**SUBJECT:** **CONDITIONAL USE / CLASS 3 SITE PLAN/ CLASS 2 ADJUSTMENT REVIEW**  
**CASE NO. CU-SPR-ADJ24-04**  
**3295 LADD AVENUE NE**  
**AMANDA NO. 24-103756-PLN**

Summary: A Conditional Use Permit and Class 3 Site Plan Review for addition to an existing parish hall.

**SITE PLAN - PROPOSED**

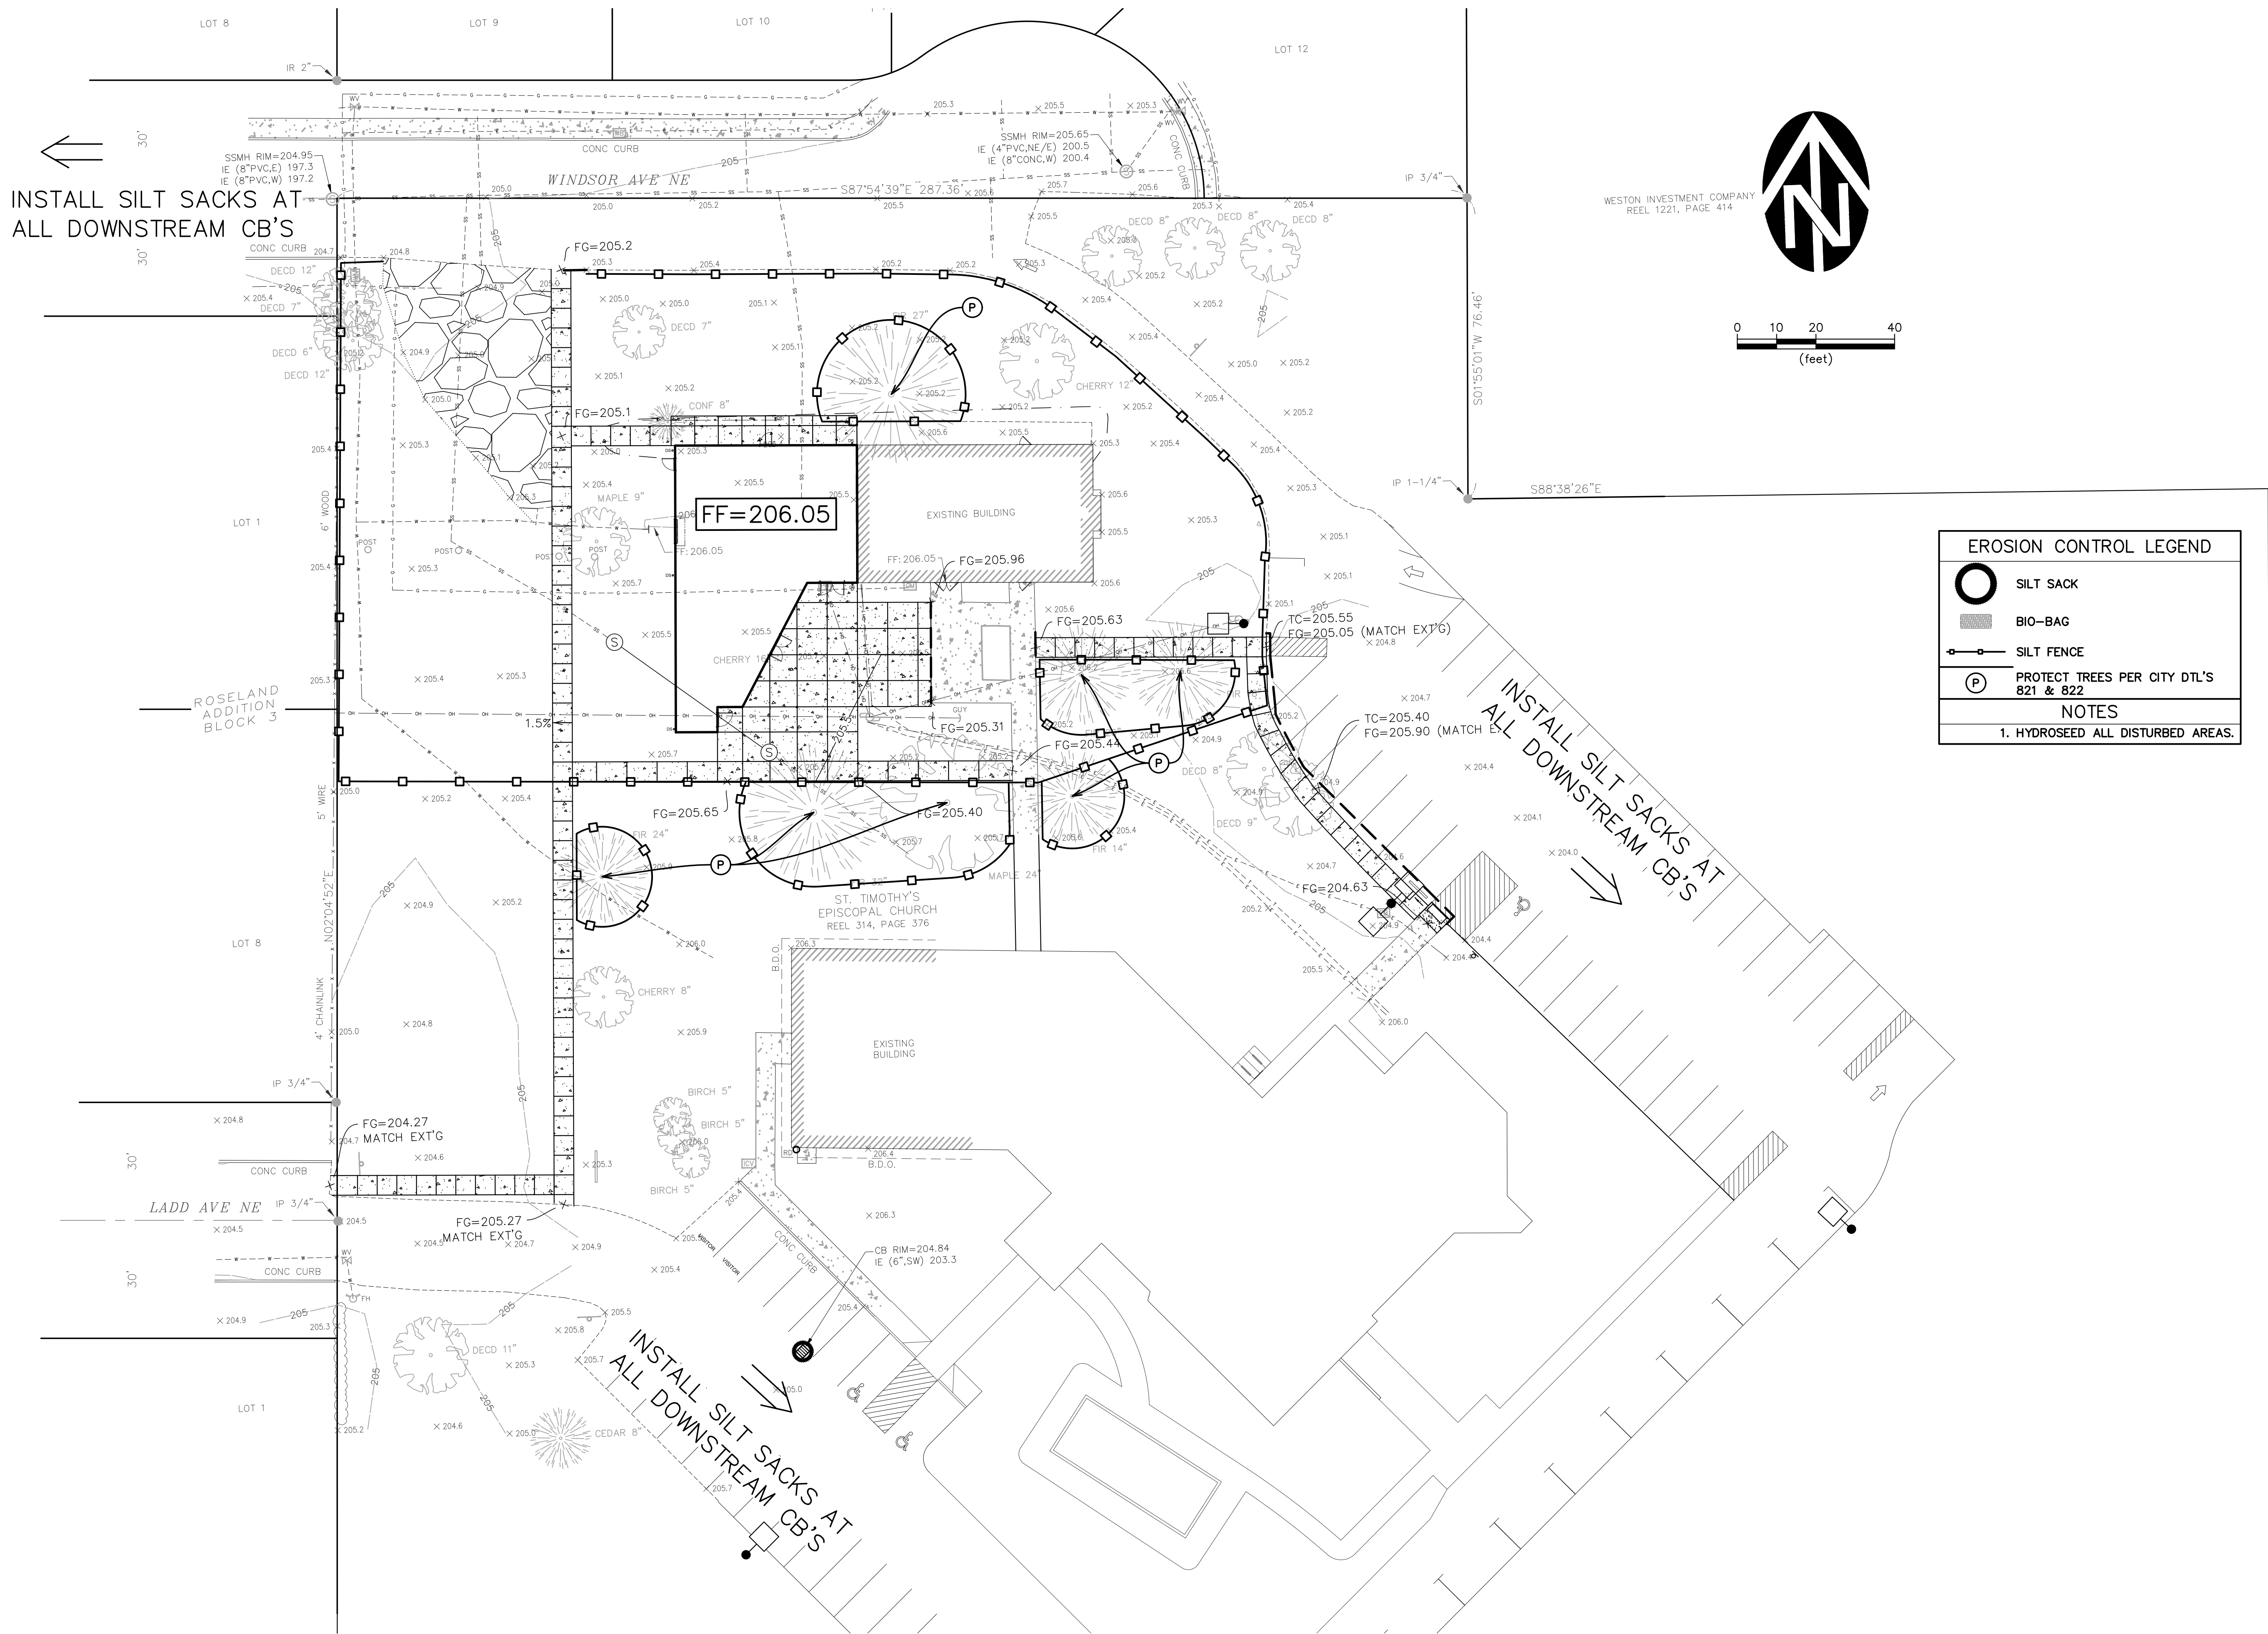
**Finding:** The proposal includes new pedestrian paths connecting Parish Hall to the northern entrance of the Church Building. The Church Building has a primary entrance along the southern façade with an existing pedestrian path not connected with the remainder pedestrian network. As such, the proposal is conditioned with the following:

**Finding:** The applicant's plans do not demonstrate conformance with the required lighting for the pedestrian paths, therefore the following condition applies:

**Finding:** The applicant's site plan indicates there are four bicycle parking spaces to be installed on site. There was no detail provided for the design of the bicycle rack. In addition, access to public right-of-way can be obtained, but based on the site plan it is unclear that no obstructions such as curbs or steps would require the user to lift the bike. To ensure all of the standards are met, the following condition applies:

The applicant's plans indicate direct pedestrian access proposed for the proposed Parish Hall Building and Church Building to Windsor and Ladd Avenue NE. However, because the property is also adjacent to Windsor Avenue NE, a pedestrian connection is required to Windsor Avenue NE.

**Condition 3:** At the time of building permit review, the applicant shall provide a pedestrian connection linking the Church Building southern entrance to the other buildings of the site.

**Condition 4:** At the time of building permit, the applicant shall provide lighting along the proposed pedestrian pathway.

EXISTING CONDITIONS,  
DEMOLITION, & EROSION  
CONTROL PLAN  
sheet:  
**C1.0**  
of:

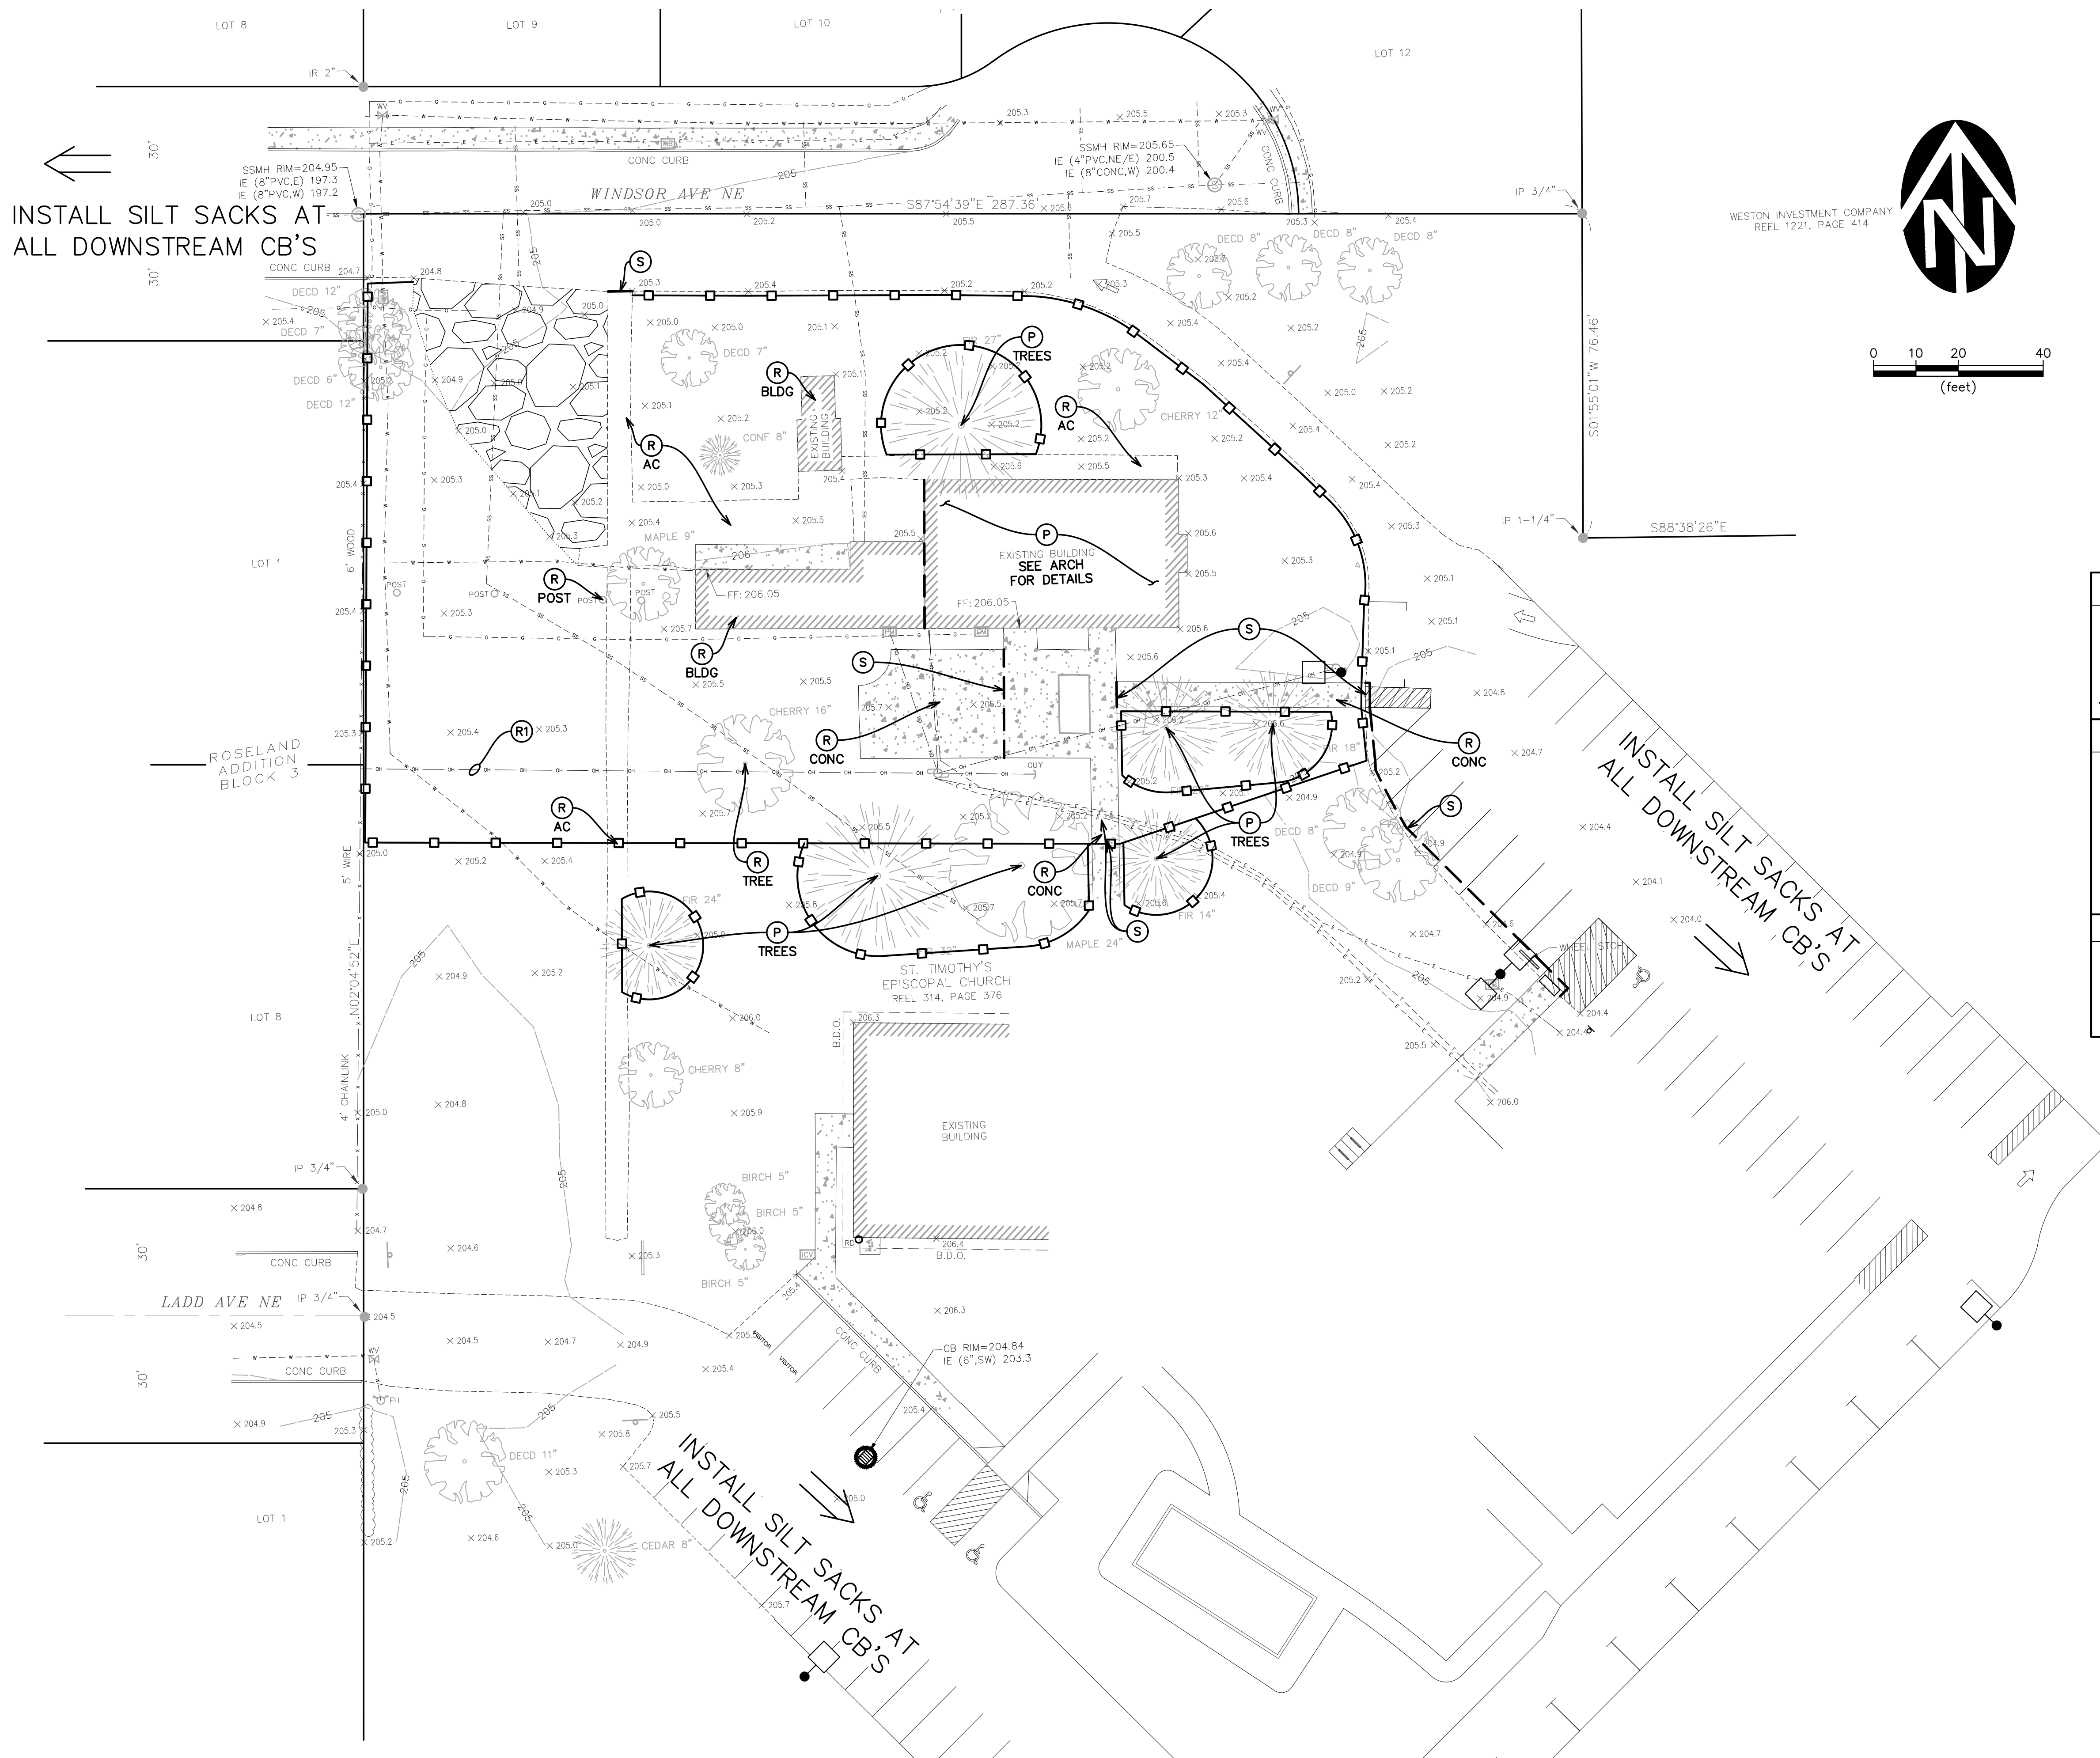
Per the Parish Hall Addition plans, it appears the new addition will likely end up underneath existing PGE three phase primary terminated on a 40' Lumen pole. Per the plans, the building height is 16'4", which has the potential to cause NESC vertical clearance violations should the roof of the new addition be accessible or non-accessible. Please note, the Lumen pole has existing in place since the 1960s. Relocation of the Lumen pole will need to be coordinated with Lumen.

Please note, Sheet C1.0 demolition notes "Contractor to coordinate w/ PGE relocate as required". Since the pole on the applicant's property is owned by Lumen it is recommended that the contractor also reach out to Lumen to relocate the pole on the applicant's property. PGE is unable to make modifications to poles owned by outside entities without prior approval from these entities.
